**Riverfront Park East Parking Lot Improvements - Phase 2
Carpentersville, IL**

ADDENDUM NO.1
August 7, 2025

To clarify information, it is necessary to provide the following Bid Addendum No.1 for the above referenced project. Bid Addendum No.1 consists of revised specifications, forms, and plan sheets.

STANDARD DUTY HMA PAVEMENT SECTION
MULTI-USE PATH

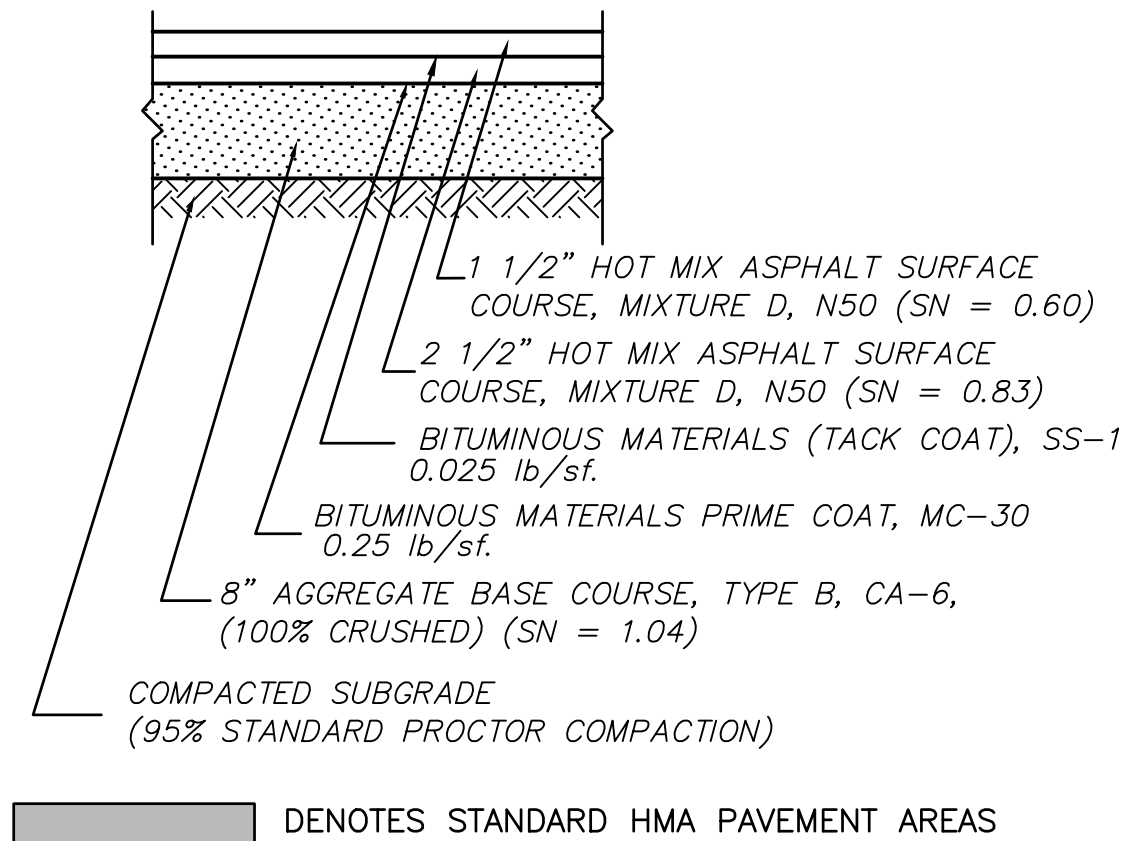
Question 1: Is there a detail for the Multi-Use Path shown on Plan Sheet 10? There is no callout for this work in the legend.

Response: Multi-Use Path Detail has been added to Sheet 27.

PROPOSED TYPICAL SECTION
WASHINGTON STREET
(FOR REFERENCE ONLY)

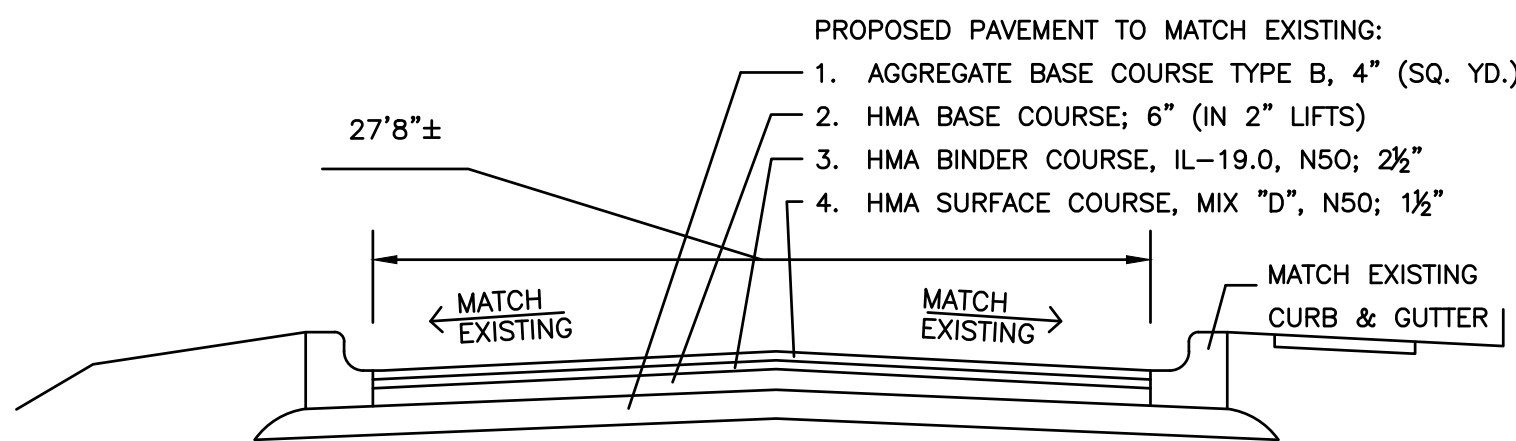
Question 2: Will there be any work performed on Washington St? The Proposed Typical Section on Plan Sheet 27 implies that there might be.

Response: No additional work is to be performed on S. Washington St. within the roadway typical section. As stated on the detail it is “For Reference Only” in case the contractor needed the full depth of the pavement section while replacing the curb and gutter in the section identified in the plans.

CONCRETE CURB AND GUTTER DETAIL

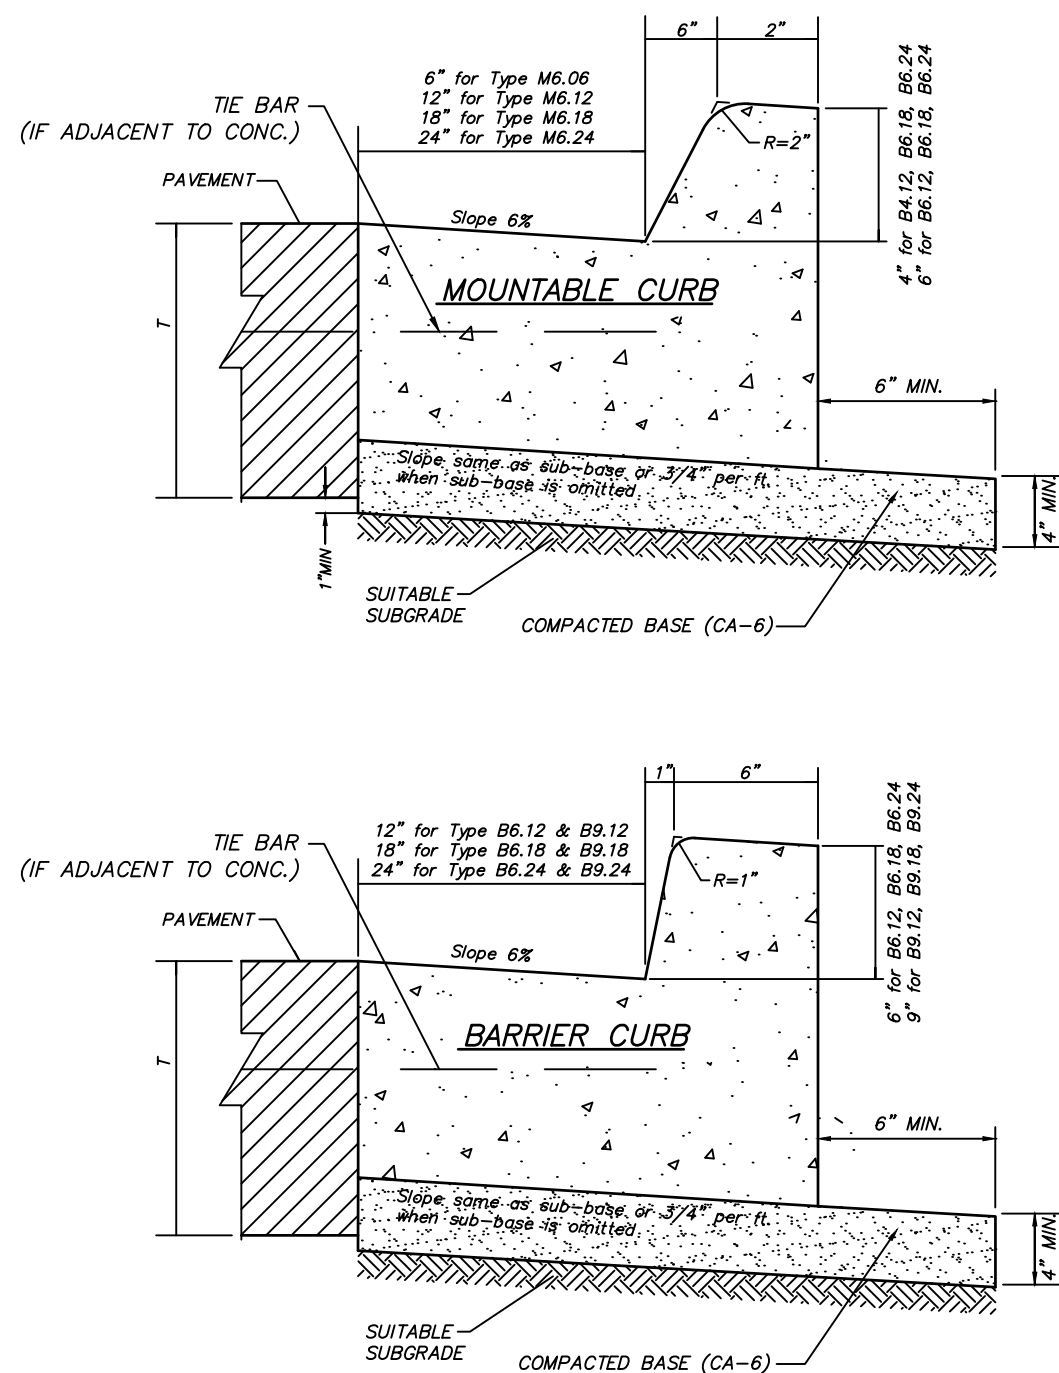
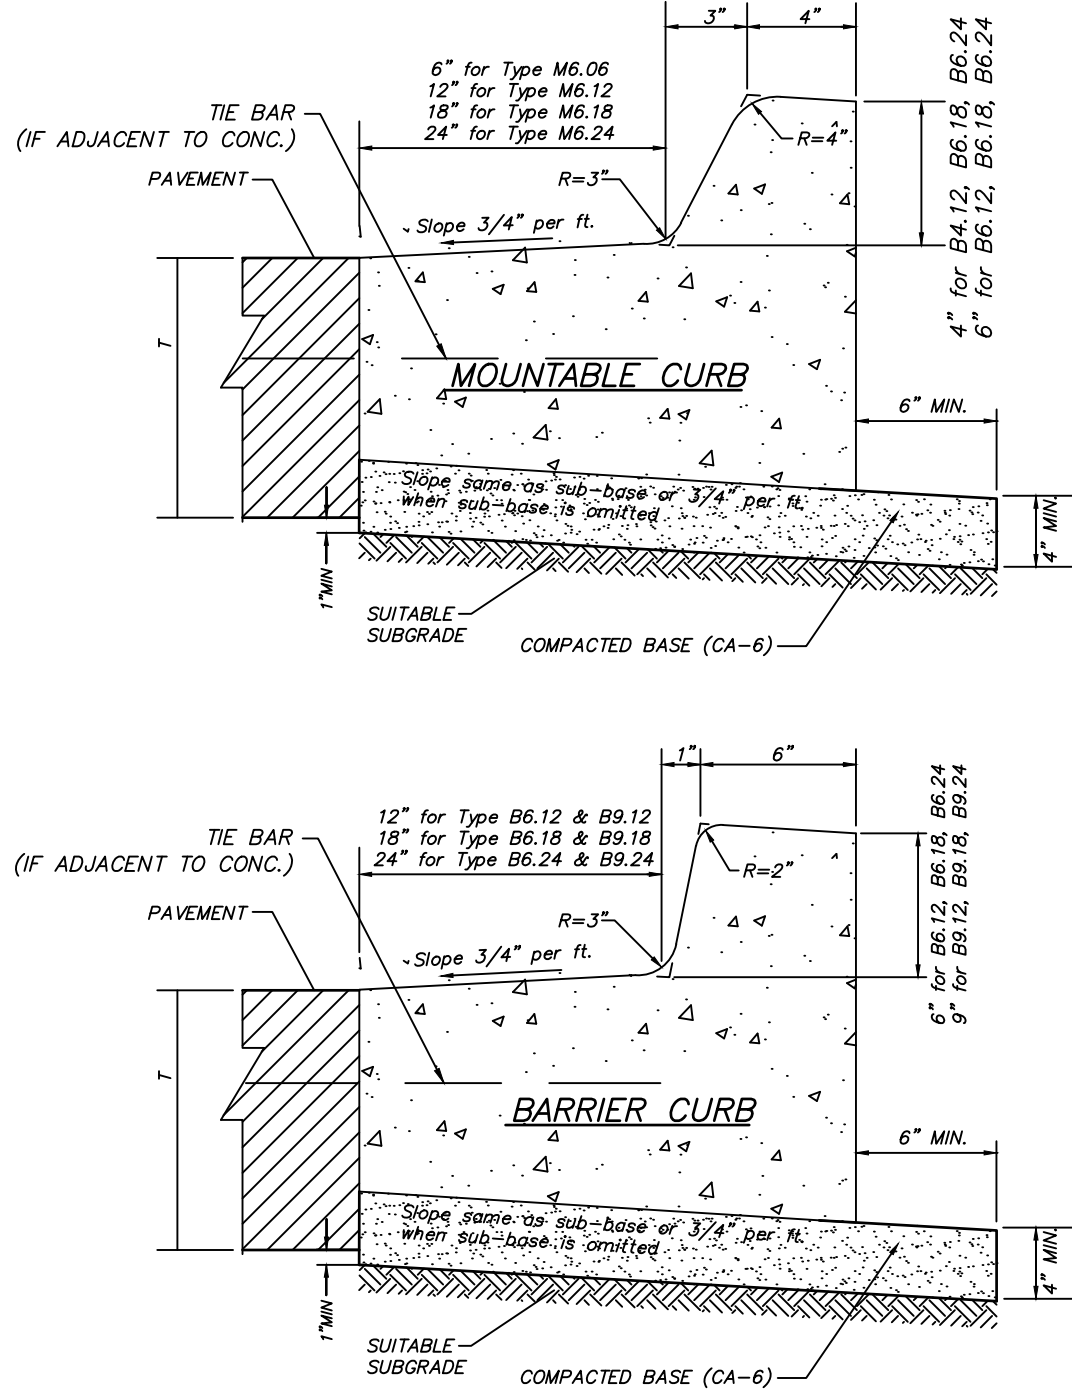
1. Sheet 01 – Cover Page – See attached/enclosed plan sheet which is to be replaced in its entirety by this addendum.
2. Sheet 03 – Summary of Quantities – See attached/enclosed plan sheet which is to be replaced in its entirety by this addendum.
3. Sheet 27 – Miscellaneous Construction Details – See attached/enclosed plan sheet which is to be replaced in its entirety by this addendum.
 - a. Multi-Use Path Detail Added to Plans.
 - b. S. Washington St. Typical Section – “For Reference Only” – Remains the same and if for reference to the Contractor Only and does not assume additional work is to be completed.
 - c. Curb and Gutter Details – Added location of Agg. Base Course, Type B 4”.
